MFN-188-79  
RLG-100-79  
July 20, 1979

SUBJECT: INFORMATION REQUESTED ON PIPE CRACKS

INFORMATION REQUESTED DURING  
JUNE 21, 1979 MEETING

Figure 1. Stress Rule Index (per new Residual Stress)

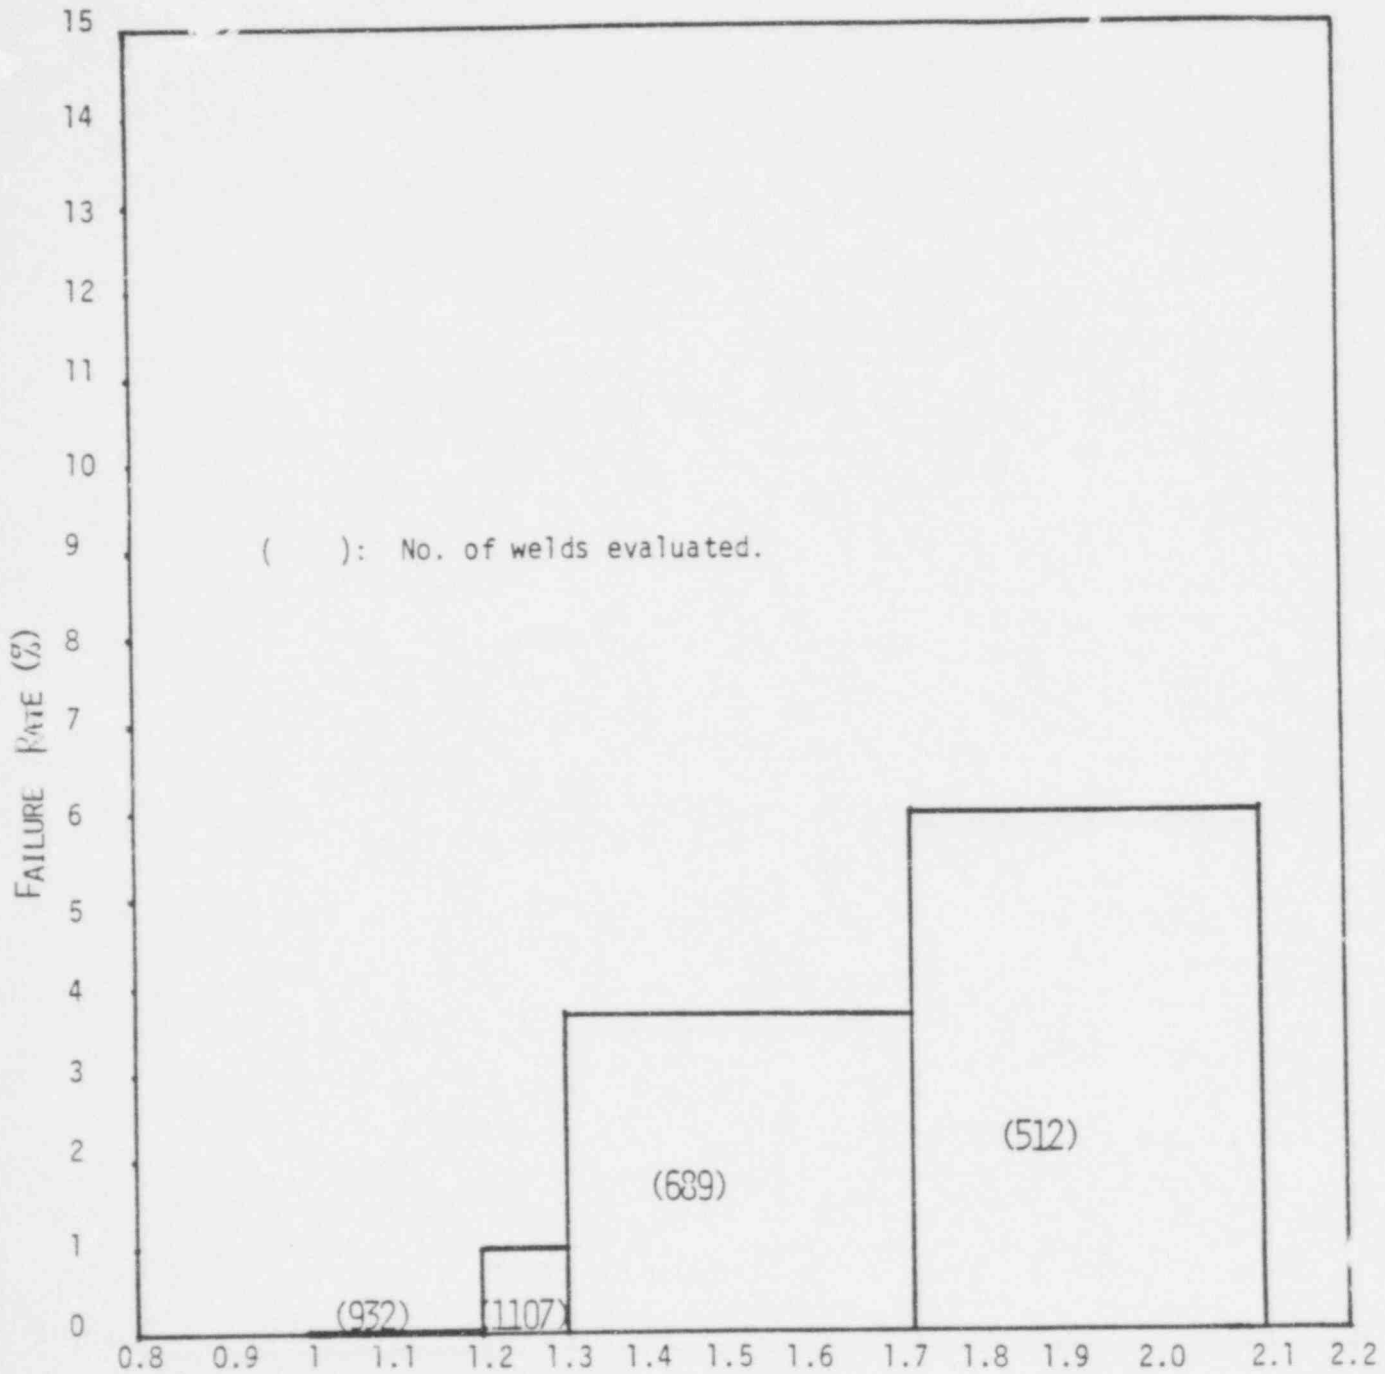
6. Provide more correlation data to establish the validity of the Stress Rule Index.

To date, stress rule values have been calculated for three BWR

piping systems: Core spray line, recirculation bypass line, and recirculation systems. No failures have occurred where stress rule index was below one. Failures did occur where the stress rule index exceeded one. Also, the failure rate increases as the stress rule index increases.

Of the 4,252 welds evaluated for BWR/1, 3, and 4, there were 3,240 welds (76%) with a stress rule index exceeding one. Figure 1 shows the failure rate for these welds as a function of the stress rule index. This figure strongly supports the validity of stress rule index for evaluating IGSCC occurrences.
